AERONAUTICAL ACCESSORIES, INC.

TECHNICAL BULLETIN TB No. AA-06173

SUBJECT: Cockpit Voice and Flight Data Recorder
(L-3 Communications FA2300)
412-709-002-103

MODELS AFFECTED: Bell Helicopter Textron model 412EP helicopters with Aeronautical Accessories Inc. 412-709-002-103 Cockpit Voice and Flight Data Recorder Kit installed per STC SR01278NY-D (formerly SR01278NY or Transport Canada Civil Aviation STC SH01-20)

Figure 2. New Configuration

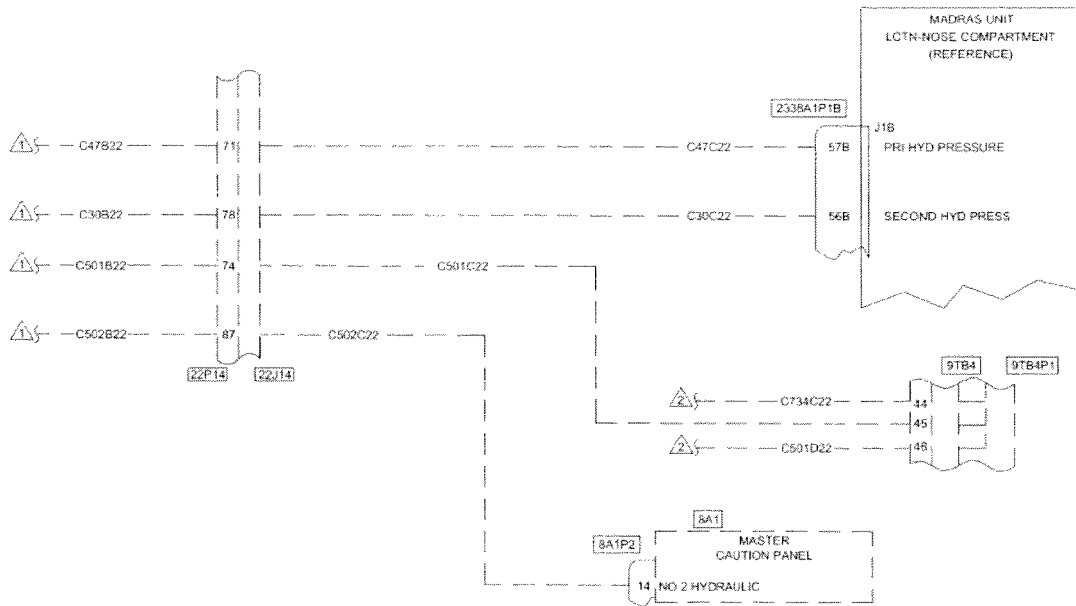
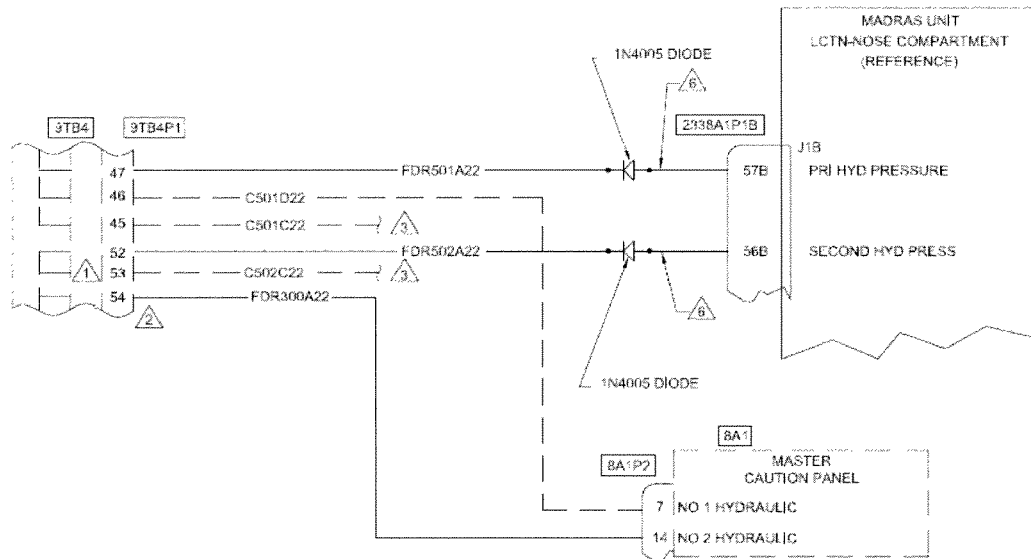
DESCRIPTION: This Technical Bulletin is being issued to advise operators of an upgrade that will connect the Flight Data Recorder (FDR) to the #1 & #2 Hydraulic Pressure switch with no interface to the hydraulic solenoid to improve reliability of the Low Hydraulic Pressure recording circuits in the MADRAS.

The CVFDR is currently wired in accordance with 412-M-98-106-1. See Figure 1.

1. Prepare the helicopter for maintenance. Disconnect the aircraft battery.
2. Gain access to the forward avionics compartment and locate terminal board 9TB4.
3. Cap and stow C30C22 and C47C22 as shown in Figure 2.

4. Route FDR502A22 from P56B of J1B on the MADRAS and terminate into 52 of 9TB4 with 1N4005 diode installed in line. Refer to Figure 2 and make certain the diode is installed in the proper polarity.
5. Route FDR501A22 from P57B of J1B on the MADRAS and terminate into 47 of 9TB4 with 1N4005 diode installed in line. Refer to Figure 2 and make certain the diode is installed in the proper polarity.
6. Relocate C502C22 from Master Caution Panel (8A1P2, Pin 14) and terminate into 53 of 9TB4. See Figure 2.

7. Route FDR300A22 from Master Caution Panel (8A1P2, Pin 14) and terminate into 54 of 9TB4. See Figure 2.
8. Reconnect the aircraft battery.
9. Perform functional test of the Flight Data Recorder in accordance with BHT-412-MMS-02
10. Annotate the helicopter historical records with accomplishment of this Technical Bulletin.

In this new configuration the presence of a ground will be equivalent to hydraulic off instead of hydraulic on. For this reason the ROSE software for the download of the Hydraulic 1 and 2 FDR files will need to be modified by the user to reflect this change in logic.

PROPOSED WIRING MODIFICATION

- 1. RELOCATE C502C22 FROM MASTER CAUTION PANEL (8A1P2, PIN 14) AND TERMINATE AS SHOWN.
- 2. IF INDICATED SECTION OF 9TB4 IS IN USE IT IS PERMISSIBLE TO RELOCATE FDR502A22, FDR300A22, AND C502C22 TO AN UNUSED SECTION OF 9TB4
- 3. REFERENCE BHT-412-MM-1, REV 0 OR LATER APPROVED REVISION, FIGURE 98-106 HYDRAULIC SYSTEMS (S/N 33101 THROUGH 36086 AND 36087 AND SUBSEQUENT).
- 4. SYMBOL — — — — — DENOTES EXISTING WIRES AND COMPONENTS.
- 5. CAP AND STOW C30C22 AND C47C22.
- 6. JUMPER WIRES TO BE LESS THAN 6 INCHES LONG AND 22 AWG WIRE PER MIL-W-22753/4.
